UNITED STATES PATENT AND TRADEMARK OFFICE

APPLICATION NO.	FILING DATE	FIRST NAMED INVENTOR	ATTORNEY DOCKET NO.	CONFIRMATION NO.
10/527,967	09/26/2005	Johann Ambrosi	740612-193	7462

Office Action Summary	Application No. 10/527,967	Applicant(s) AMBROSI, JOHANN	
	Examiner JAY R. RIPLEY	Art Unit 3679

DETAILED ACTION

(Horimoto Figure 19)

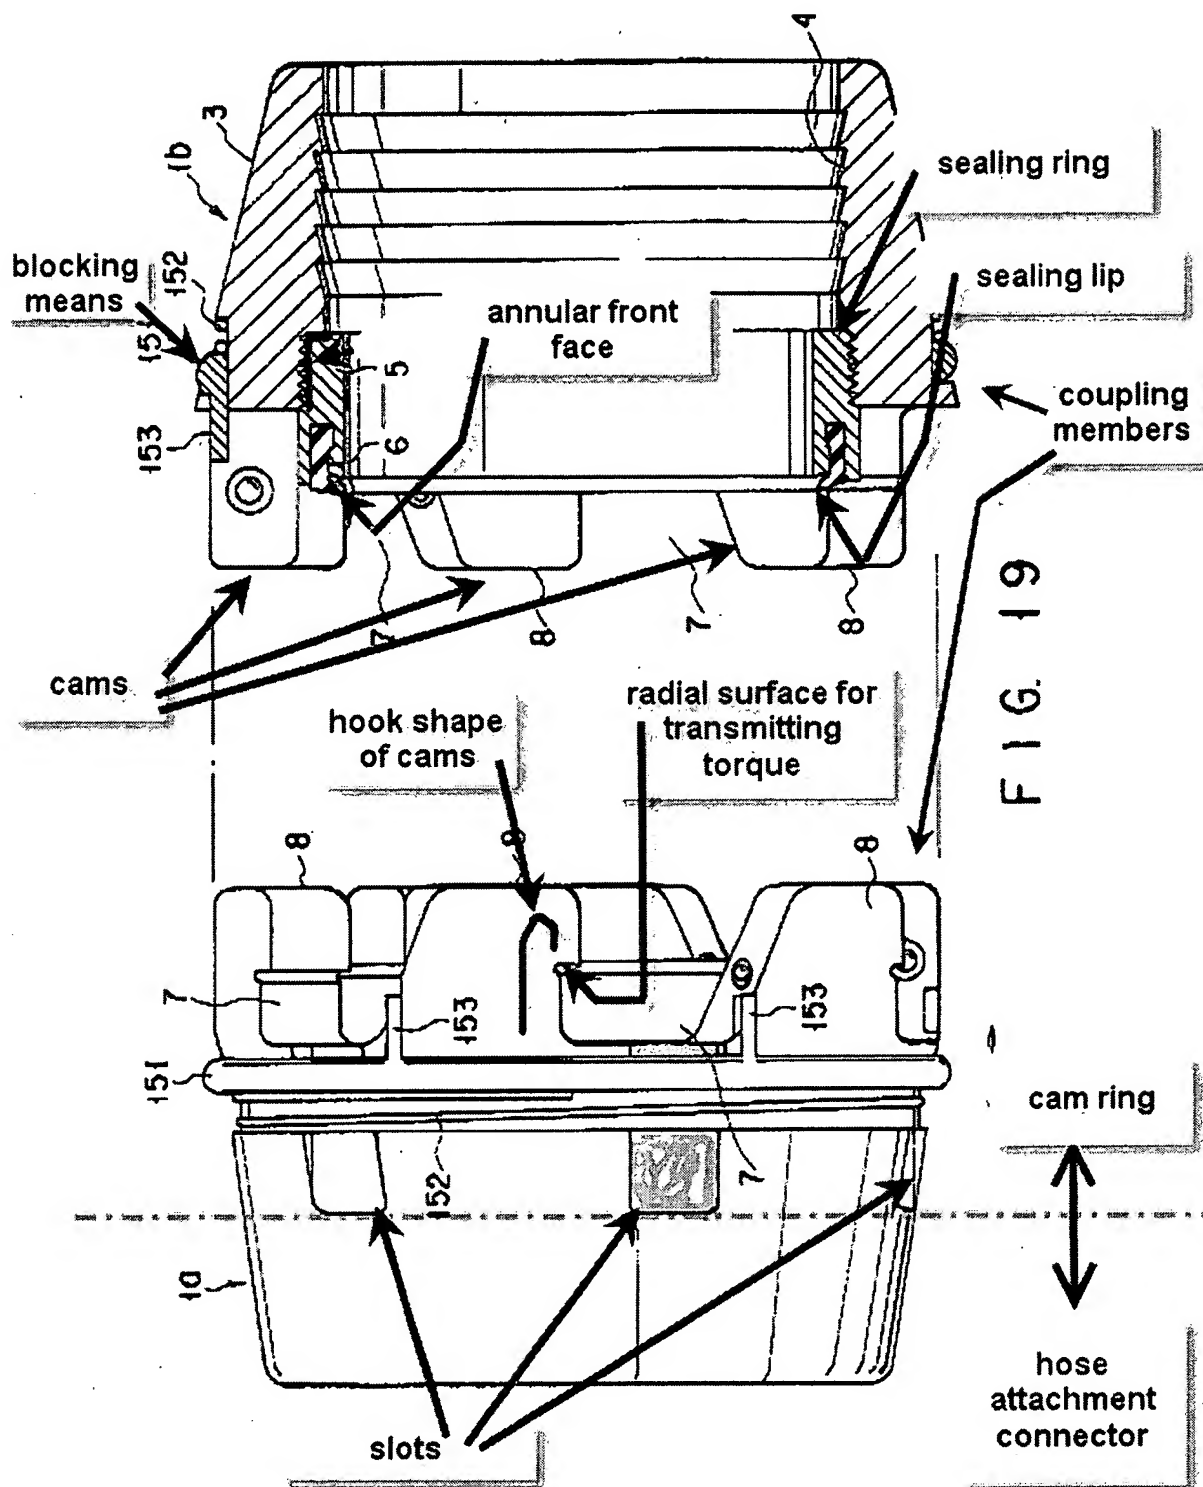
In regard to claim 1, Horimoto discloses in Figure 10 and Figure 19, the figures shown below, a symmetrical hose coupling comprising

a pair of like coupling members (1a and 1b, as observed in Figure 19, below),

each of the coupling members having a cylindrical hose attachment connector (4) and a cam ring integrally formed with the cylindrical hose attachment connector (as observed in Figure 19, below),

the cam ring having a plurality of integral cams (8) arranged on the periphery of the cam ring and projecting from the cam ring (the slots noted in Figure 19, below and in Attachment A, result in the cams projecting radially from the cam ring - the blocking means appears to be positioned by the slots - note that the slots "bottom", radially inner surface, is the outer radial surface of the cam ring), the cams being hook-shaped in a tangential direction of the cam ring and each having a radial surface area (9 in Figure 10) for transmitting an axial force, and the

In regard to claim 7, Horimoto further discloses that the radial surface areas of the cams are inclined in relation to the tangential direction (column 8, lines 26-30, and observed in Figure 10, above).

In regard to claim 10, Horimoto further discloses that a blocking means (lock claws 153 as observed in Figure 19, above, and as disclosed in column 13, lines 19-34) are provided for locking the pair of coupling members with each other in a coupled condition.

(close-up of Horimoto Figure 19)

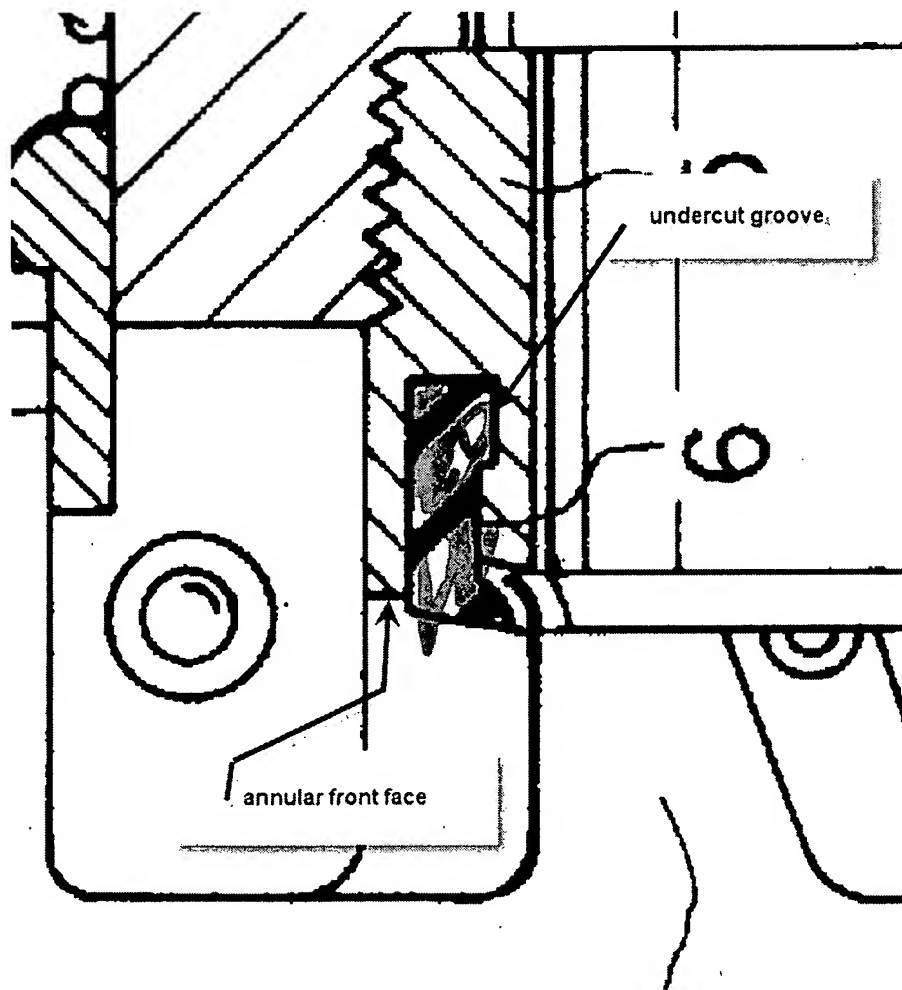
In regard to claim 8, Horimoto further discloses, in Figure 19, above, and close-up of Figure 19, below, that the cam ring has an annular front face radially inwardly of the cams and an annular undercut groove is recessed in the annular front face for receiving a shaped sealing ring having a sealing lip which protrudes axially beyond the front face of the cam ring.

FIG. 19

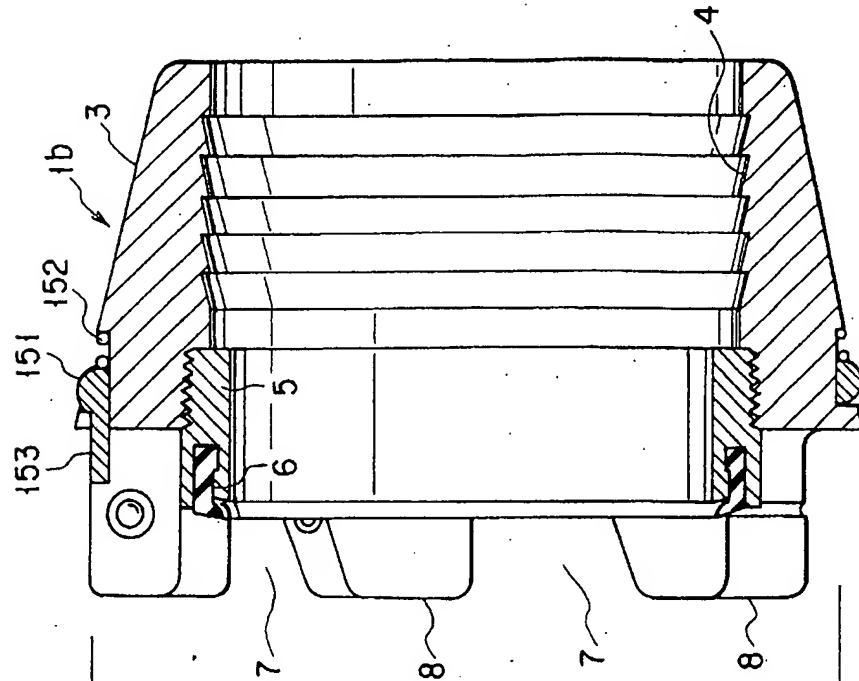
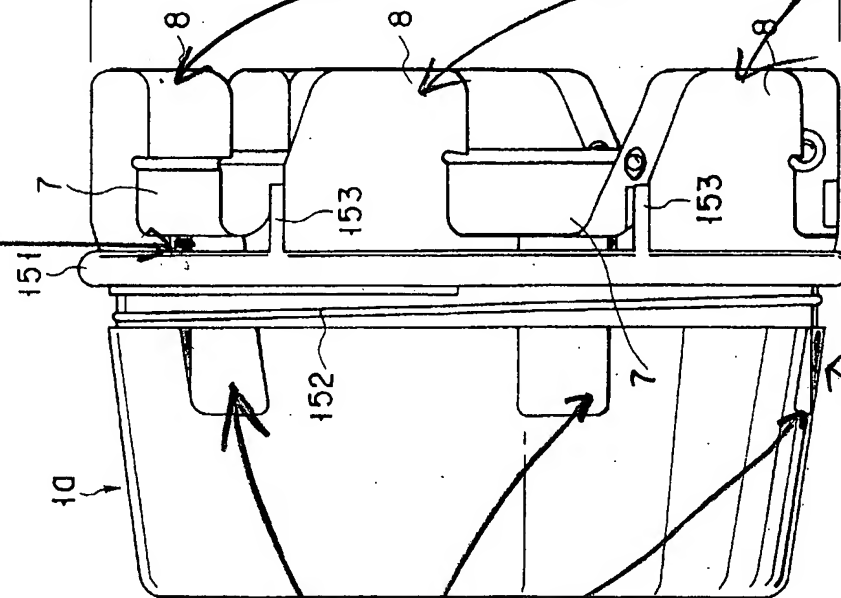
Concerning the Applicant's assertion starting in page 6, line 9, of the reply filed 17 December 2007, that the prior art of Horimoto (U.S. 5,857,713) does not teach or suggest cams that project radially from a cam ring, the argument is not persuasive. As can be observed in Horimoto Figure 19, see Attachment A, the slots as first noted in page 7 of the Office action mailed 06/19/2007 result in the cams of Horimoto projecting radially from the noted cam ring. As specifically noted in Attachment A, Figure 19 shows "side" surfaces (shaded in

Attachment A) of the noted slots, thereby further buttressing the interpretation that the cams of Horimoto project radially from the cam ring. The Examiner notes that the cam ring outer circumference is the "bottom" radial surface of the noted "slots".

CAMS

NOTE
"SIDE"
SURFACE
(SHADED)

SLOTS RESULTS IN CAMS
PROJECTING RADIALLY FROM
CAM RING.
